**TOWN OF NEWBURGH  
PLANNING BOARD  
TECHNICAL REVIEW COMMENTS**

**PROJECT: GARDNER RIDGE**  
**PROJECT NO.: 12-29**  
**PROJECT LOCATION: SECTION 75, BLOCK 1, LOT 4.12**  
**PROJECT REPRESENTATIVE: DOCE ASSOCIATES**  
**REVIEW DATE: 11 SEPTEMBER 2015**  
**MEETING DATE: 17 SEPTEMBER 2015**

RE: Conceptual Site Plan - Gardner Ridge  
Gardnertown Road  
Tax Parcel: Section 75 Block 1 Lot 4.12  
Town Project No. 2002-29

**CONCEPT PLAN**  
 FOR  
**GARDNER RIDGE ASSOCIATES LLC**

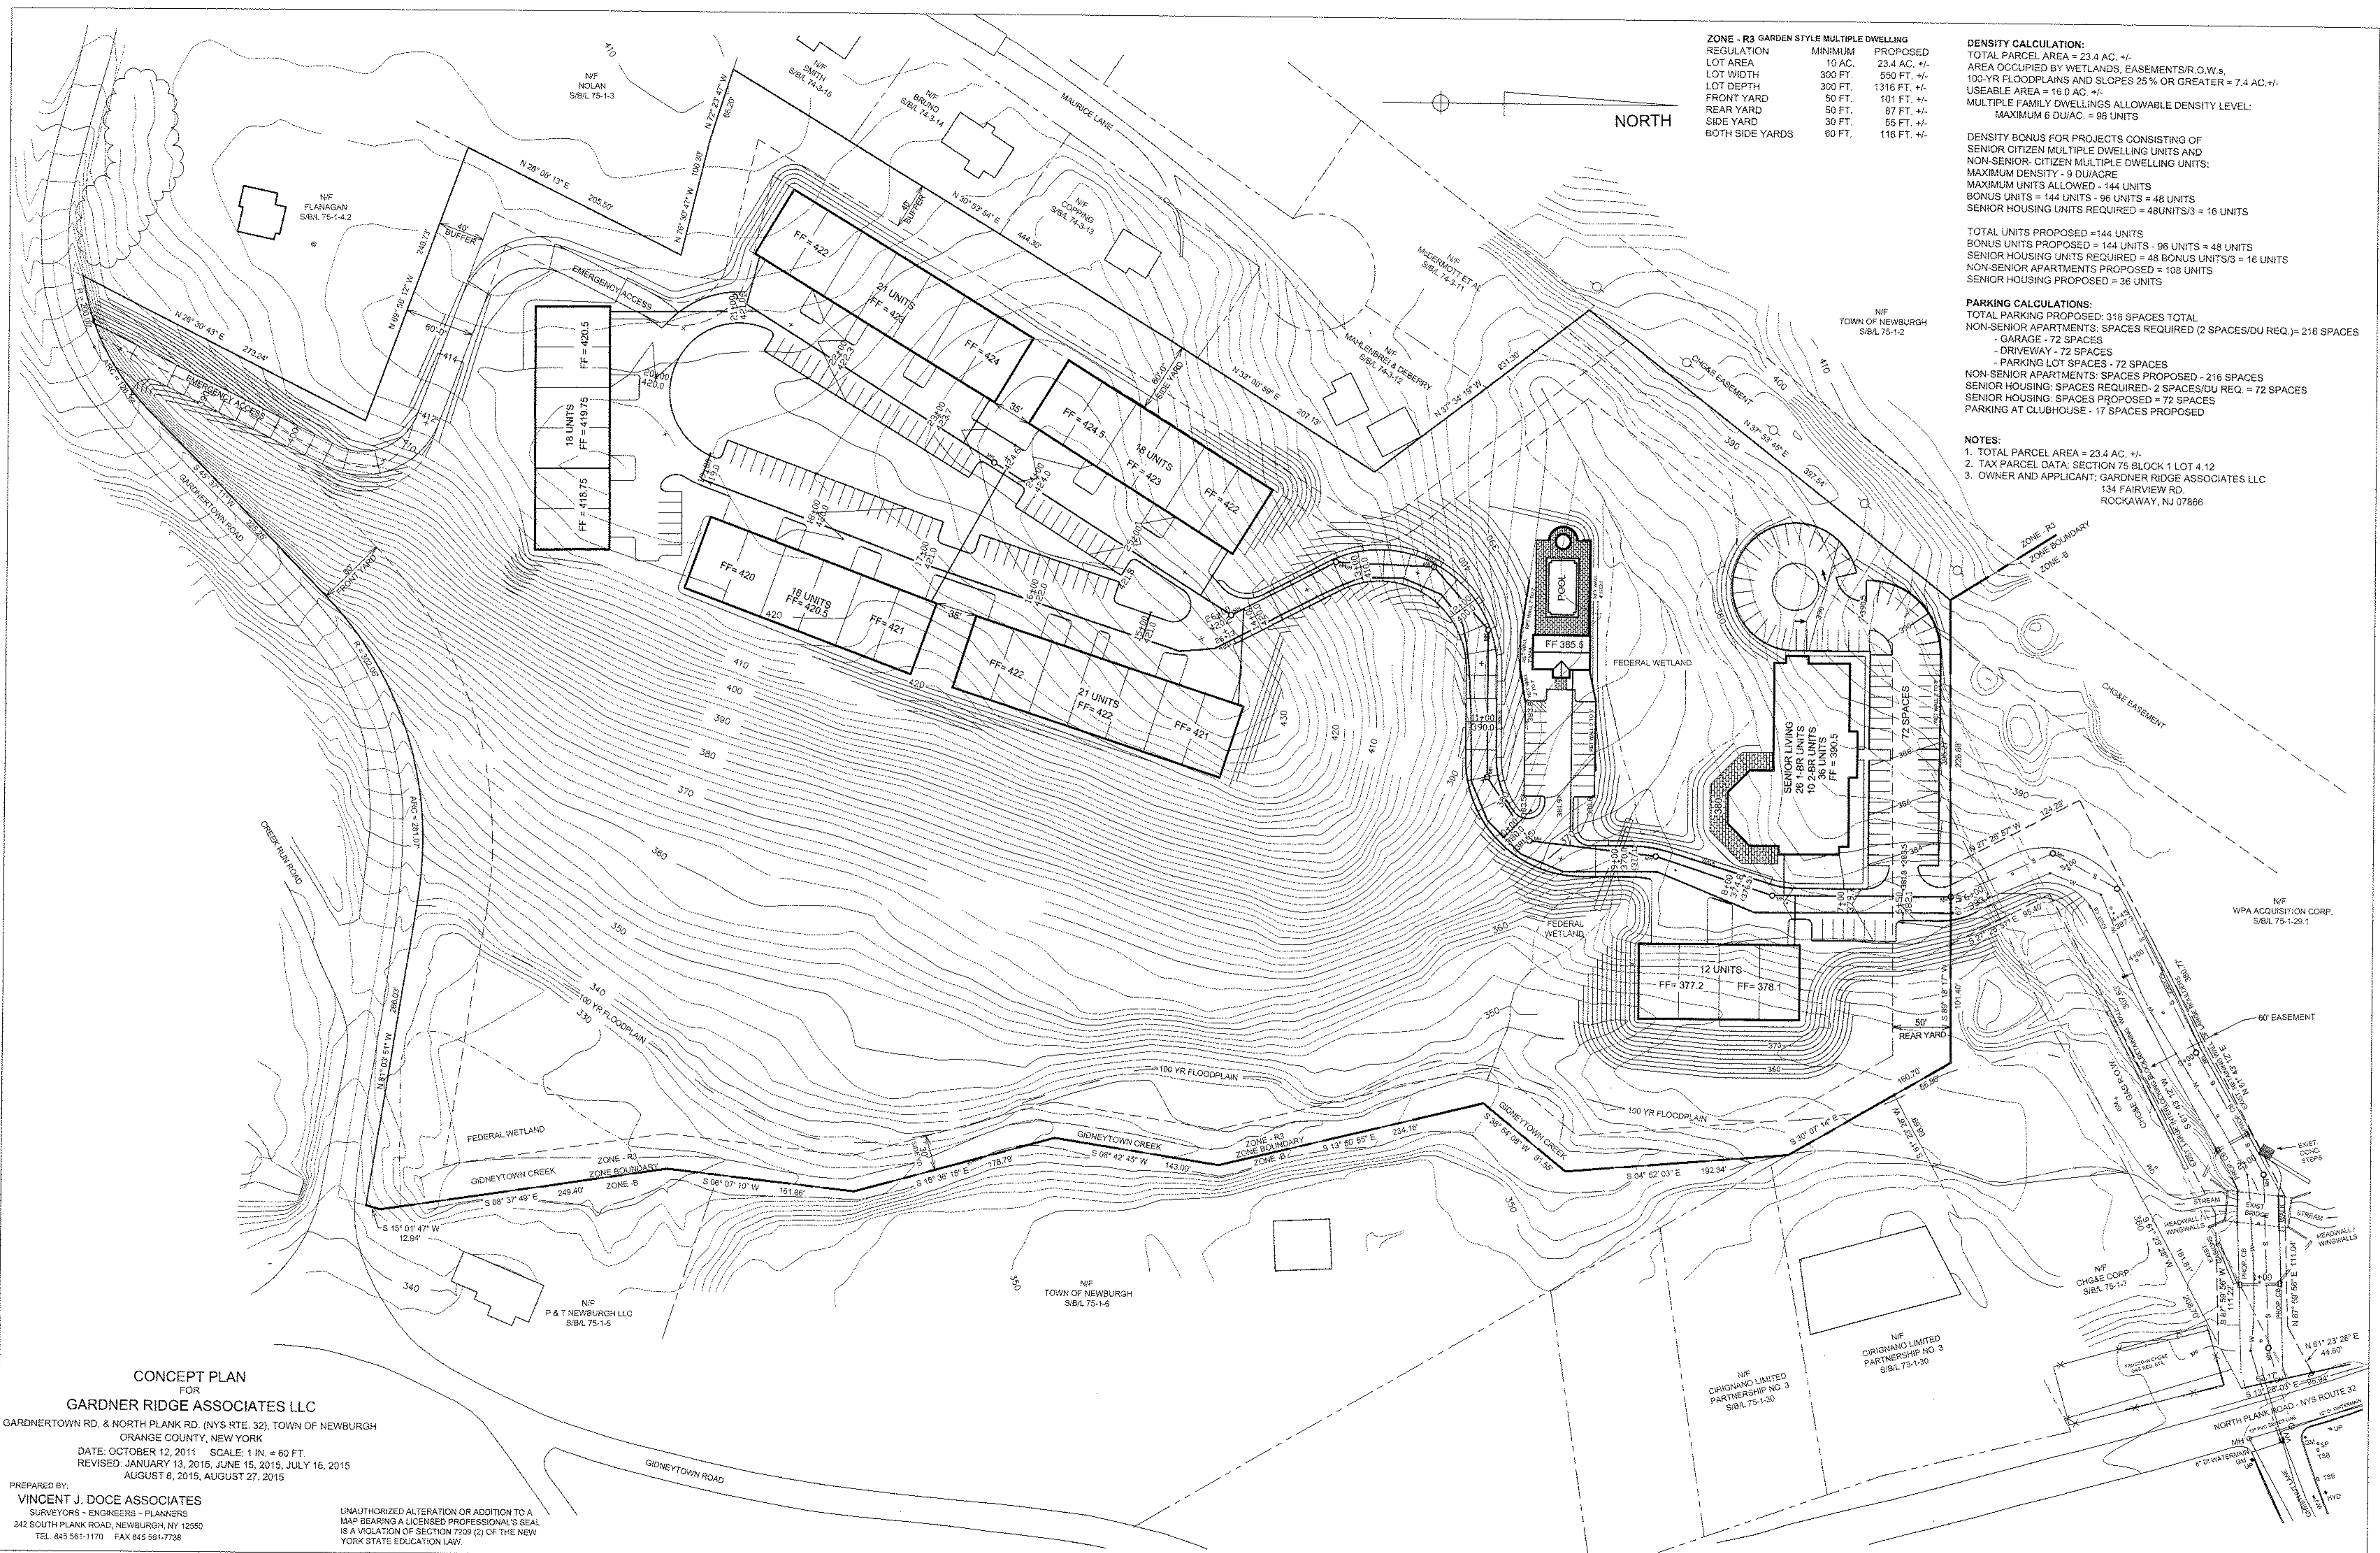
1. Bulk table should be checked for side yard setbacks proposed. It appears the proposed side yard is 60 feet minimum.
2. Senior units have a maximum unit size which should be added to the plans and considered during design of the senior citizen apartment structure. (Section 155-48B(4)).

3. The Planning Board should discuss the need for sidewalks from the site to North Plank Road shopping areas.
4. Currently valid jurisdictional determination of federal jurisdiction wetlands on the site should be provided for review. Federal wetlands are proposed to be impacted by the project.

5. Mechanism to control access at emergency access roads should be evaluated. Buffer requirements exist along emergency access road which must be addressed based on the amount of grading.

6. If buildings are proposed to have decks on the rear, rear decks should be depicted based on proximity to setbacks and buffers.
7. Building height should be identified in the bulk tables and addressed based on fire access requirements.

10. Several of the structures are located on extensive fill areas. Specialized construction techniques may be required to address placement of structures on such fill.
11. Future submissions should address compliance with Town and NYSDEC Storm Water Management Regulations.
12. Handicap accessible spaces in the area of the Senior Living should be provided in compliance with ADA regulations. This may reduce number of parking spaces based on ADA layout.
13. The Planning Board should discuss the parking requirements, 72 of the spaces are identified as garage spaces with 72 of the spaces also being identified as the vehicle parked in front of the garage. Use of the garage for other than parking may result in significant issues regarding parking on the project site.
